MEADOWBROOK CROSSING

# MEADOWBROOK CROSSING PRELIMINARY LANDSCAPE PLAN

PCD PROJECT NUMBER: SP-17-002

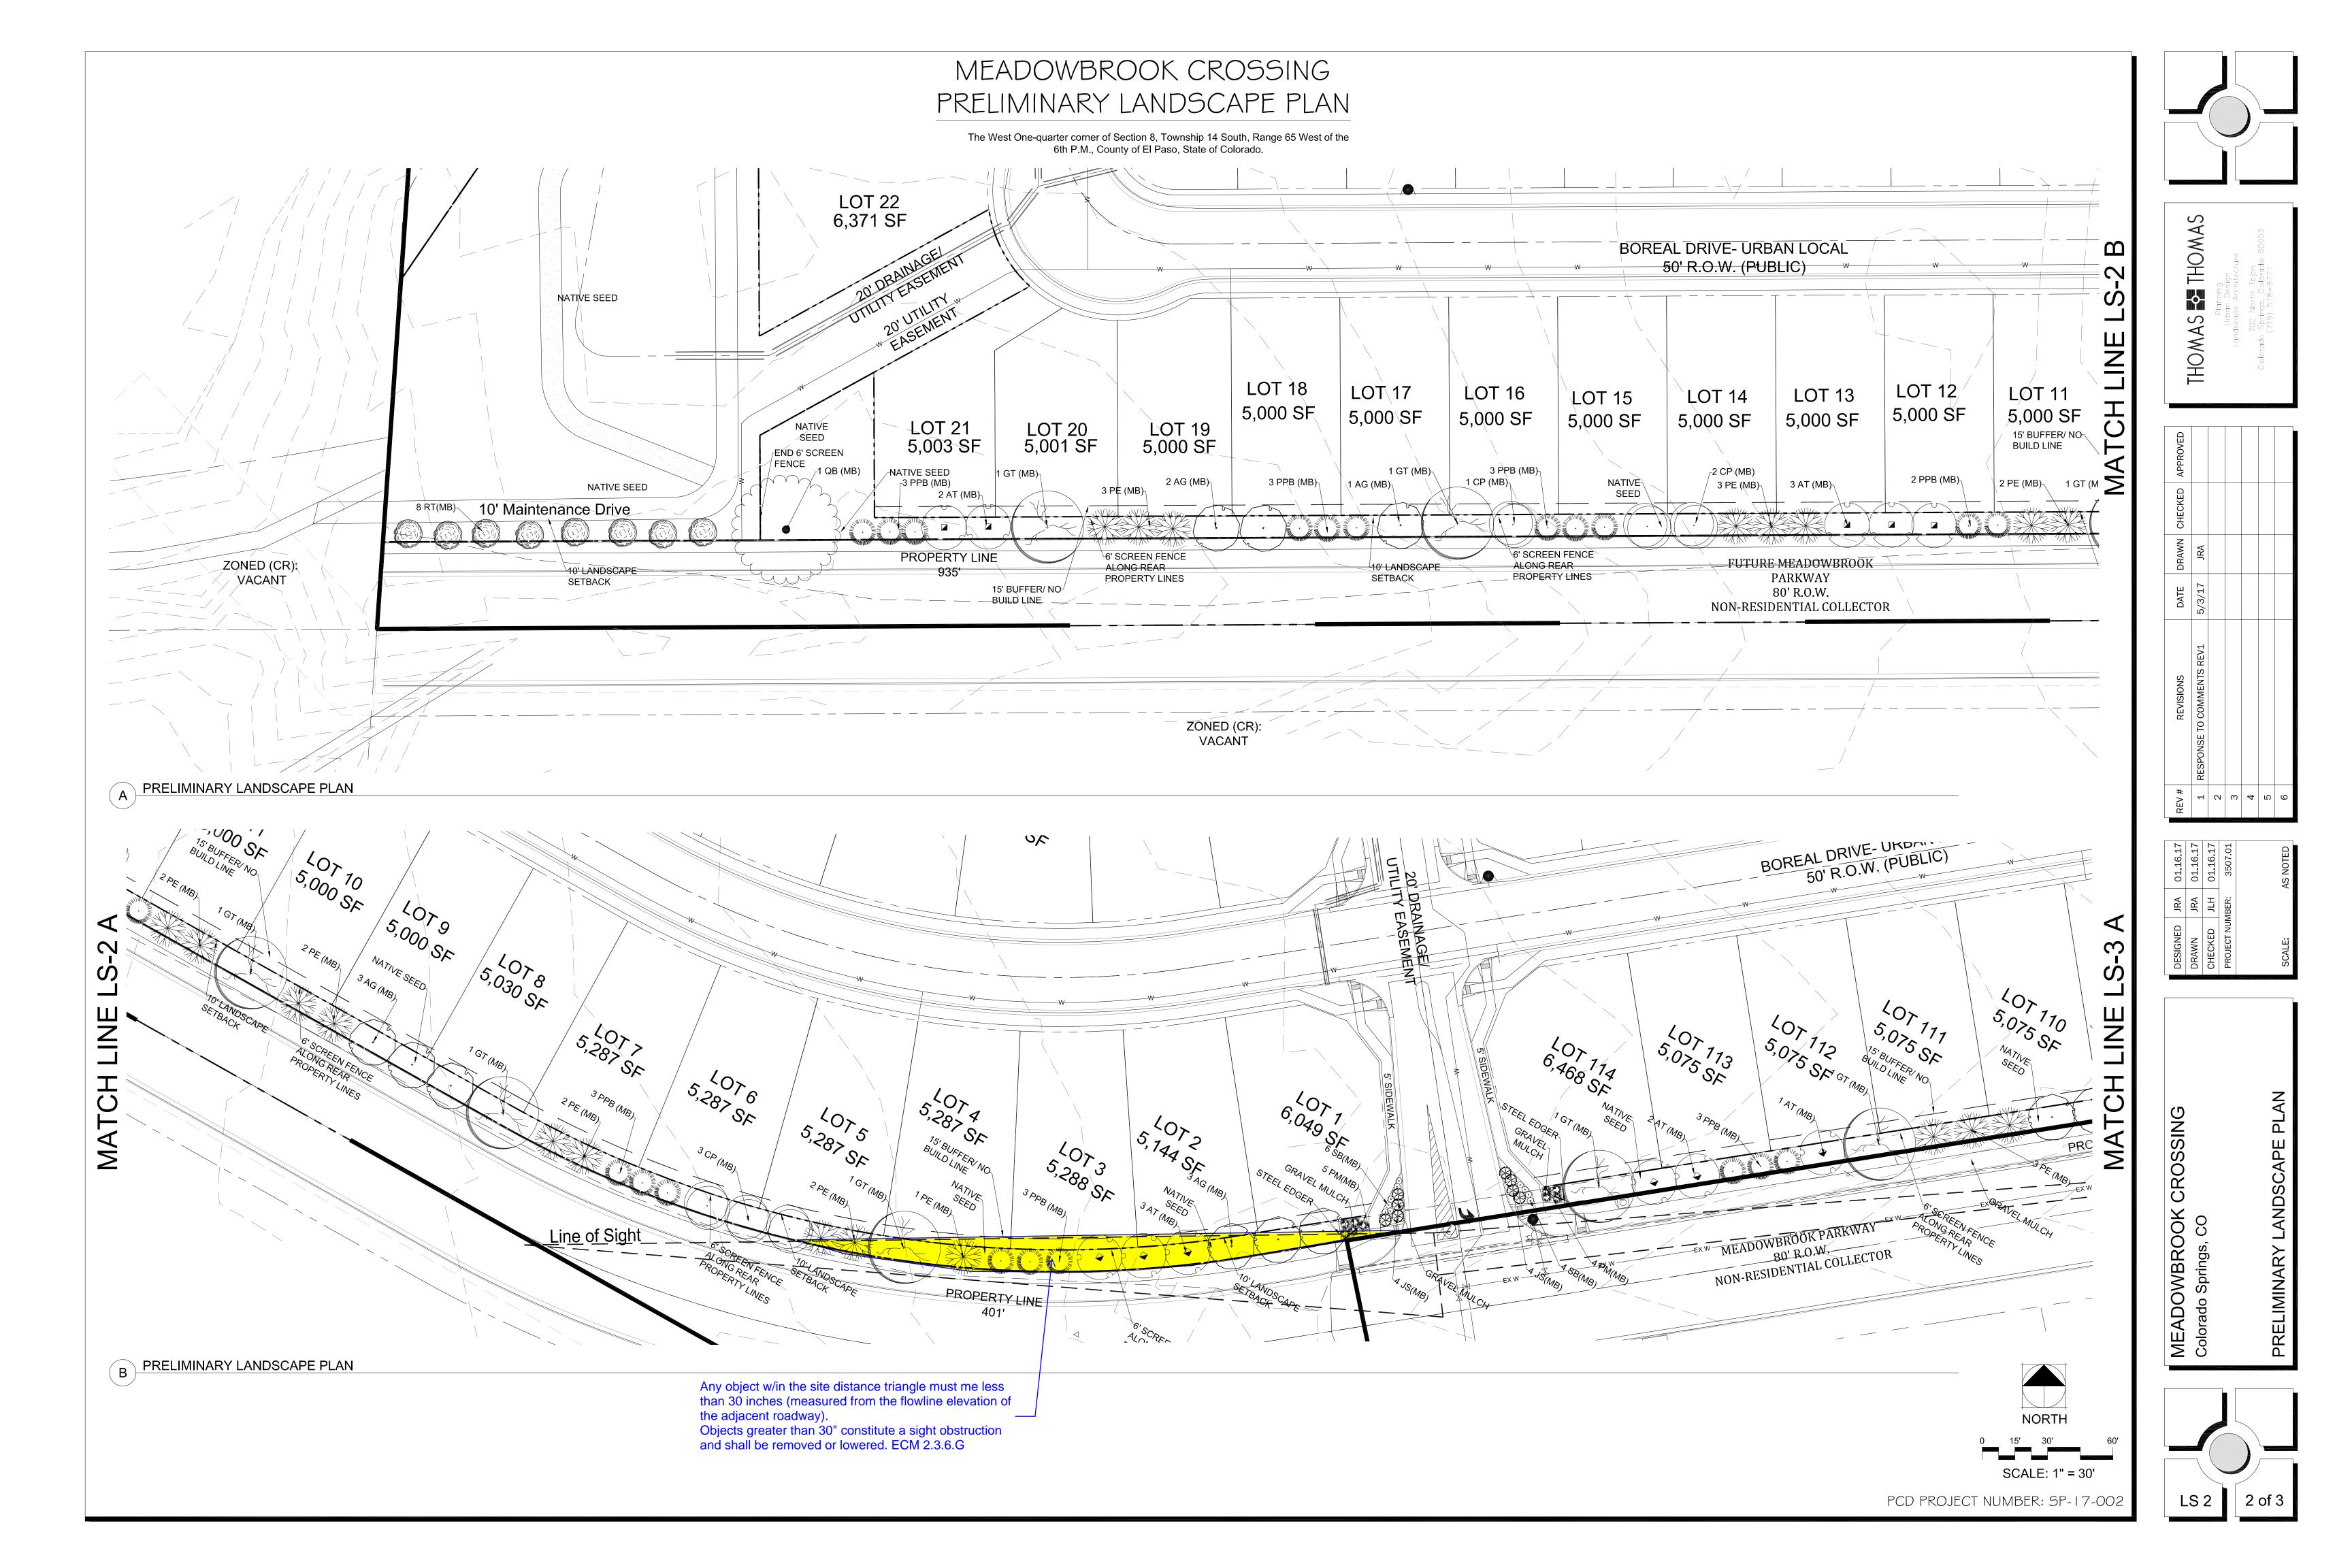
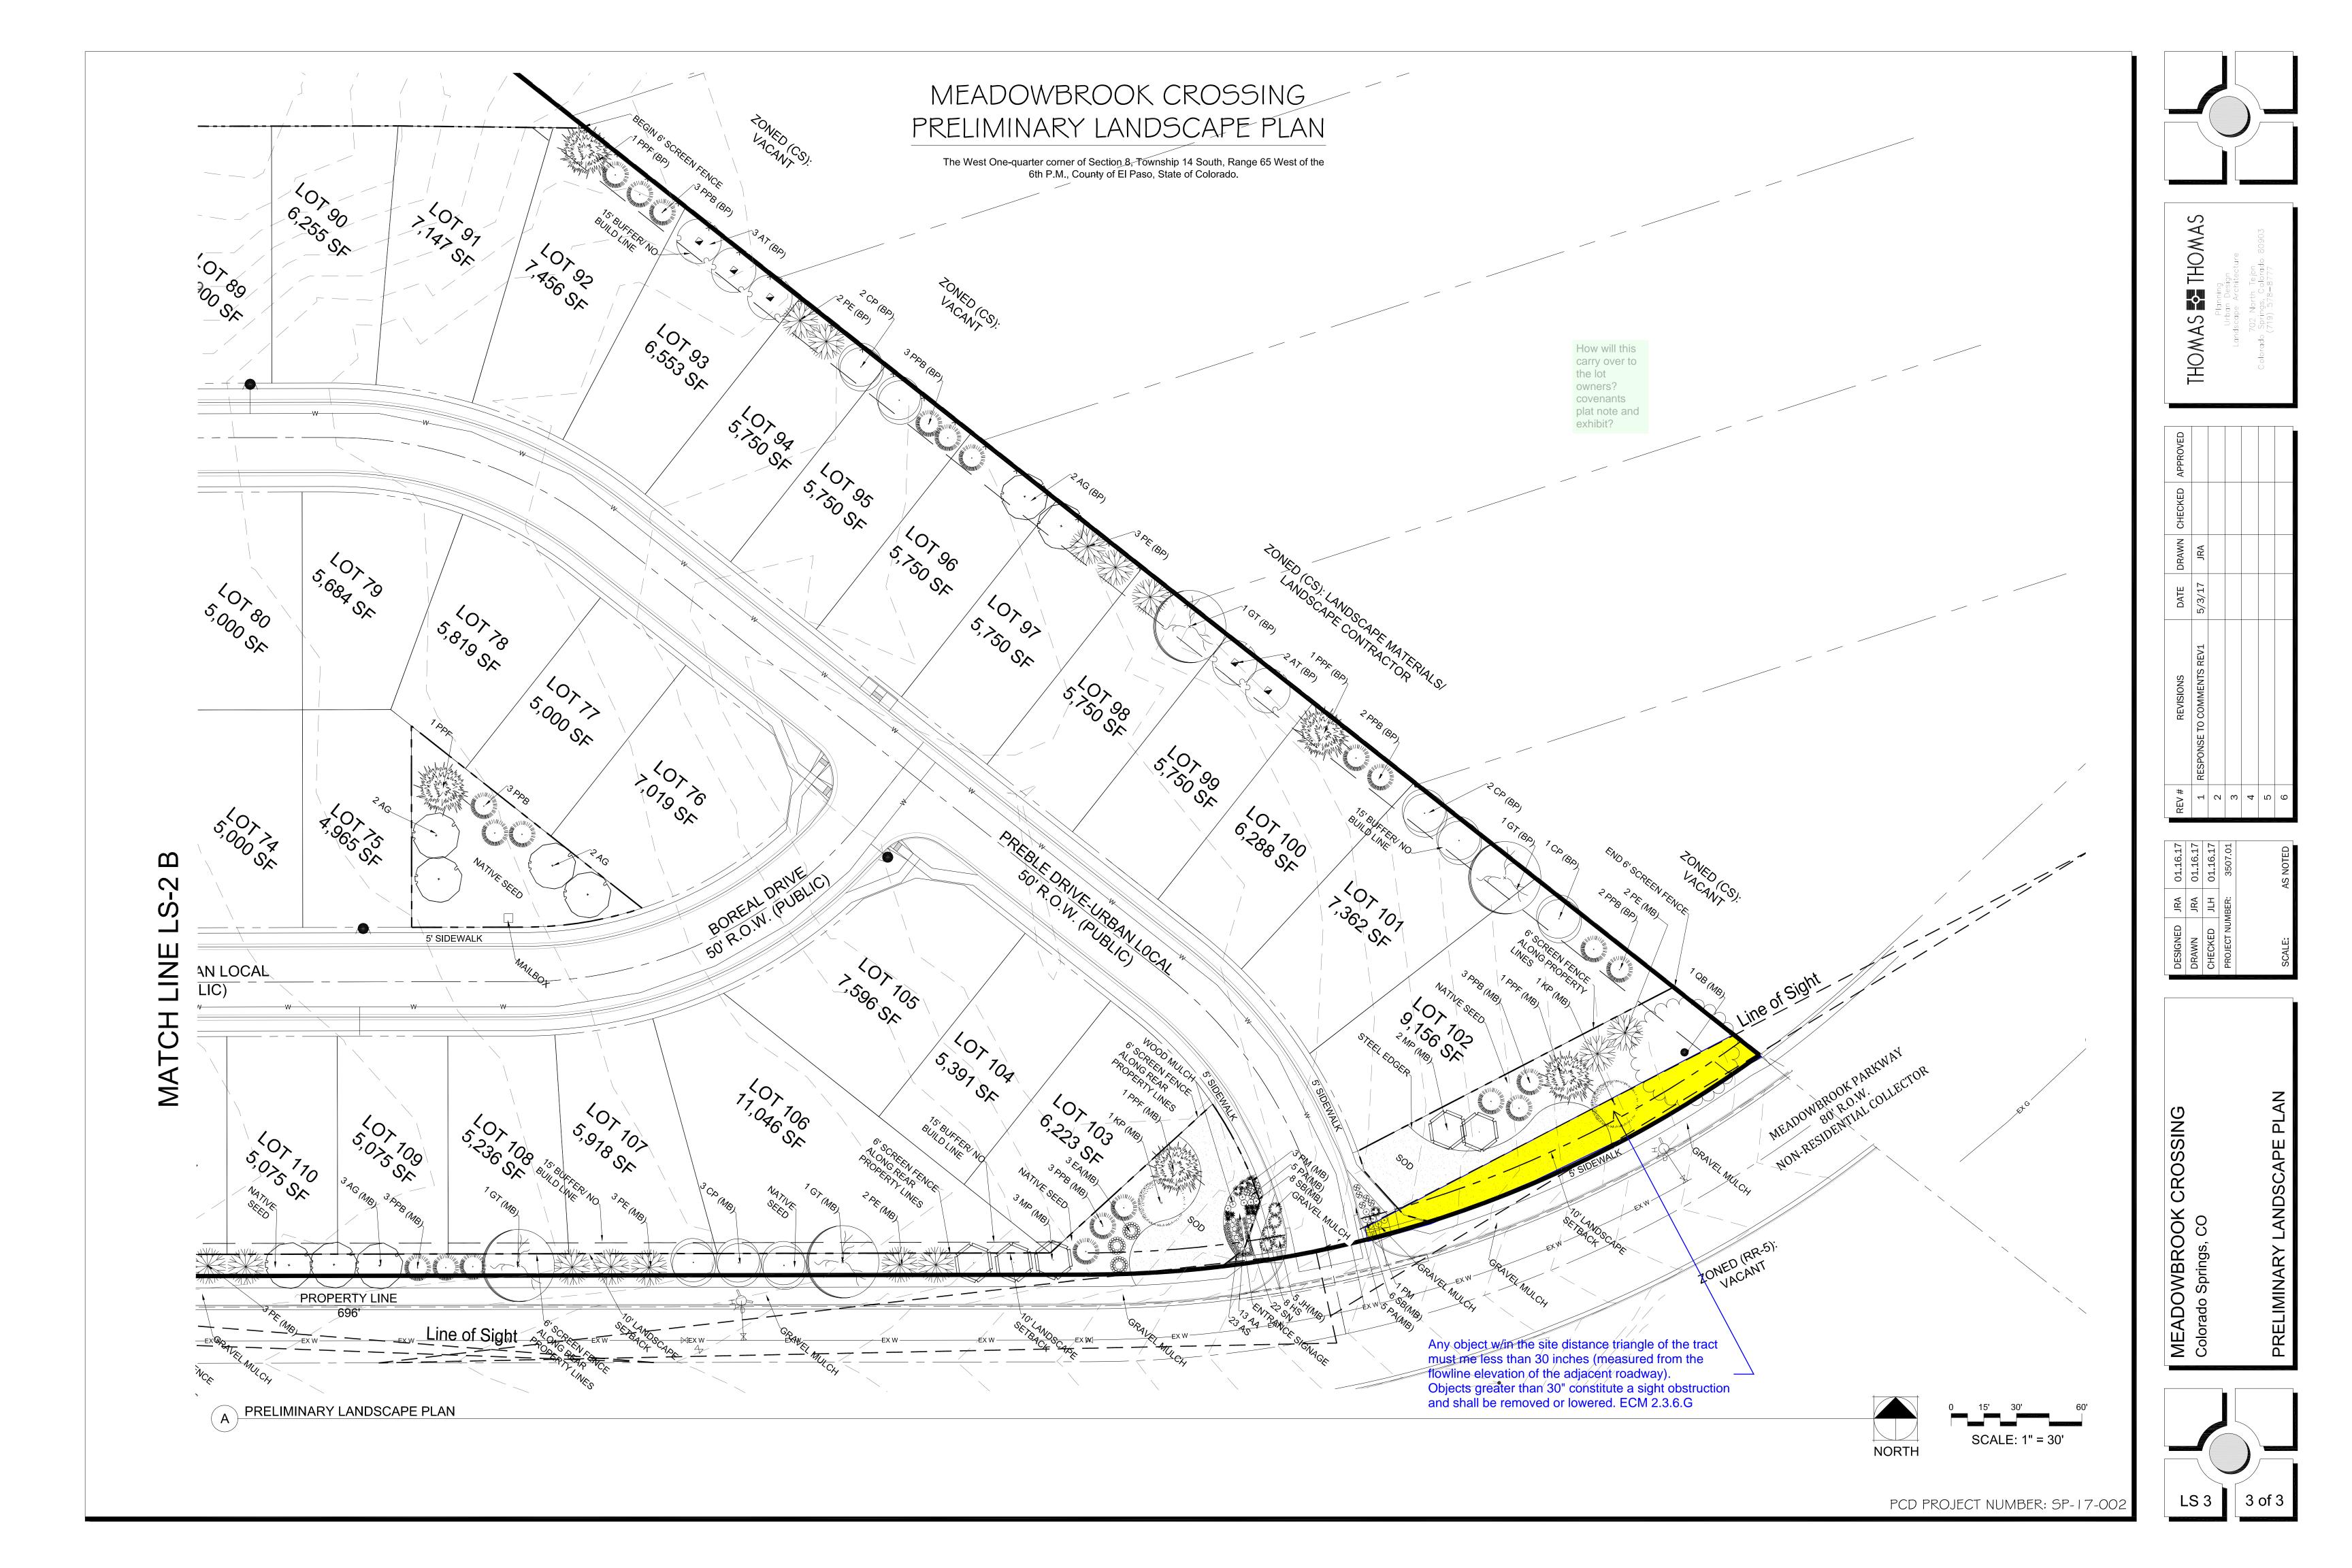
Any object w/in the site distance triangle must me less than 30 inches (measured from the flowline elevation of the adjacent roadway).

Objects greater than 30" constitute a sight

obstruction and shall be removed or lowered. ECM

2.3.6.G

Any object w/in the site distance triangle of the tract must me less than 30 inches (measured from the flowline elevation of the adjacent roadway). Objects greater than 30" constitute a sight obstruction and shall be removed or lowered. ECM

2.3.6.G
